From: "Sean Dent" <sean@southernplanning.co.nz>
Sent: Mon, 9 Mar 2026 15:37:41 +1300
To: "Courtney Briggs" <Courtney.Briggs@qldc.govt.nz>
Subject: RE: RM260148 - Tahuna Futurer Investments Limited
Attachments: J2086_193 Fernhill Road_RC RFI_2026.03.09.pdf

I am the processing planner of RM260148 - Tahuna Futurer Investments Limited and I have completed my initial review of the application.

Job Title
PROPOSED FLAT- Daly

Project Location
193 Fernhill Road,
Fernhill, Queenstown 9300

Sheet Title
Elevations / Window & Door Schedule

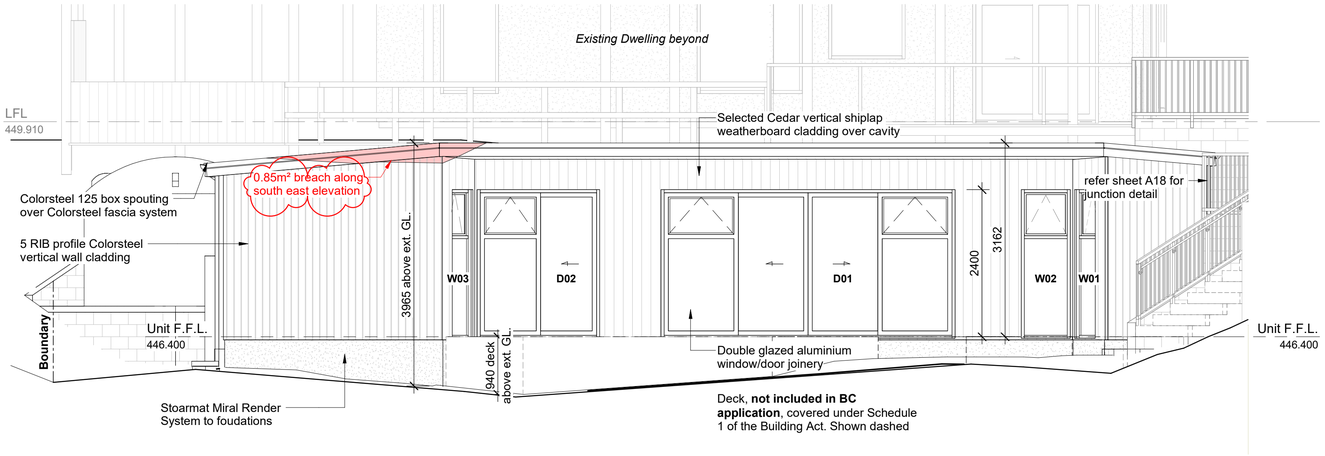
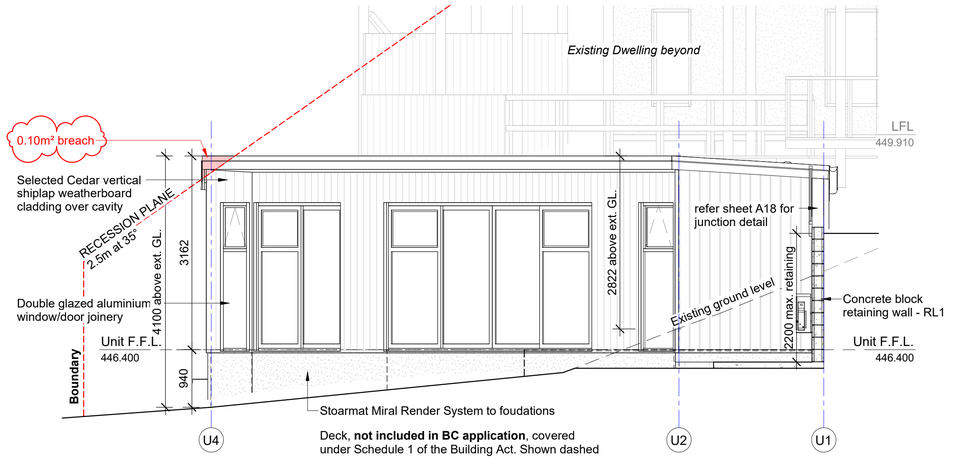
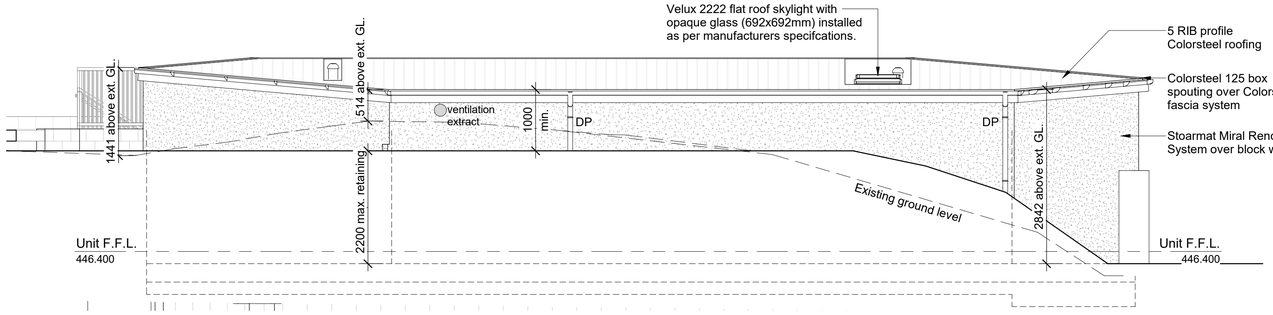
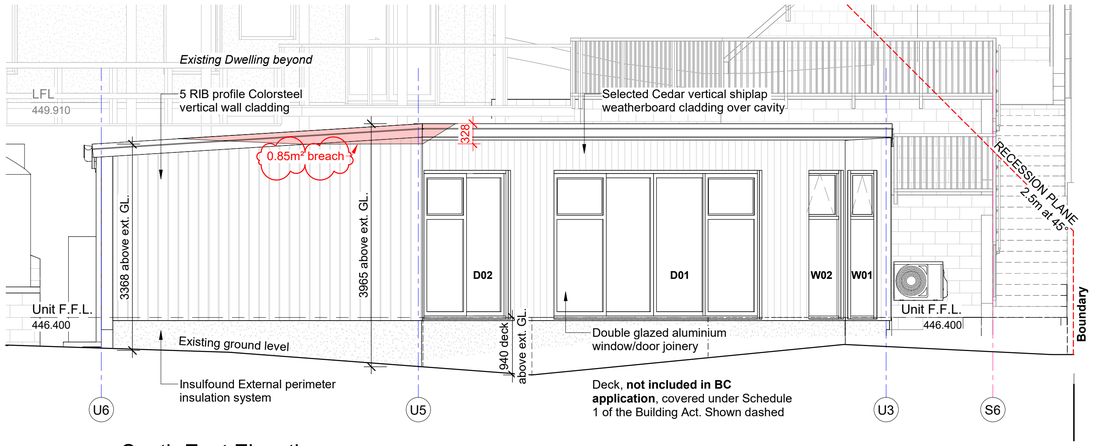
Recession planes: One of the changes that the UIV has made to the PDP is that recession planes are now applicable to all buildings on sloping sites. To allow an understanding of any potential recession plane breaches, these will need to be shown on the plans. Please find **attached** some revised plans from the architects that illustrate a small breach of recession plane on the east / southeast elevation and the northern elevation. The breaches are negligible in scale being 0.85m^2 and 0.10m^2 respectfully. It is considered that this scale of infringement

would be imperceptible compared to a fully compliant building on the site and that the effects on neighbours and the wider environment will be less than minor.
